PROPOSED CHANGE

NBC05-DivB-09.13.04.03.(02)(06a)-add-HSB-A_ed.doc

Document	NBC 2005 CNB	Document
Provision	A-9.13.4.3.(2) and (6)(a)-add 2010	Exigence
Committee	ES-HSB Joint Task Group on Protection Against Radon Ingress	Comité
Minutes	1 st meeting of JTG, 3 rd meeting of JTG Radon	Procès-verbaux

Add new Appendix Note A-9.13.4.3.(2) and (6)(a) as follows:

Figure A-9.13.4.3.(2) and (6)(a)

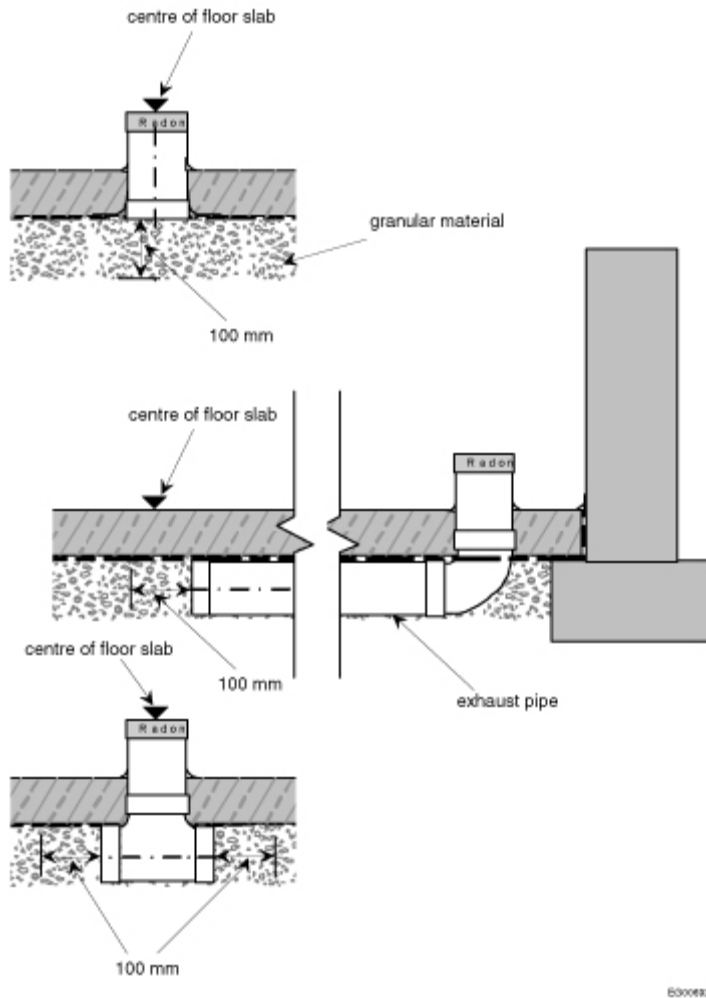
A-9.13.4.3.(2) and (6)(a) Effective Depressurization. To allow effective depressurization of the space between the air barrier and the ground, the extraction opening (the pipe) should not be blocked and should be arranged such that the entire space between the air barrier and the ground is connected to it. This will ensure that the extraction system can maintain negative pressure underneath the entire floor (or in heated crawl spaces underneath the air barrier). The arrangement and location of the extraction system inlet(s) may have design implications where the footing layout separates part of the space underneath the floor.

Related appendix notes currently don't offer any guidance as to how to achieve effective depressurization of the space between the air barrier and the ground. The current term "subfloor depressurization" also does not recognize that heated crawl spaces may have to be protected from the ingress of radon even though there isn't a subfloor.

The appendix note explains what is meant by “effective depressurization” for both the performance-based and prescriptive requirements. It offers guidance as to how to achieve effective depressurization of the space between the air barrier and the ground and recognizes that heated crawl spaces may have to be protected from the ingress of radon even without a subfloor present.
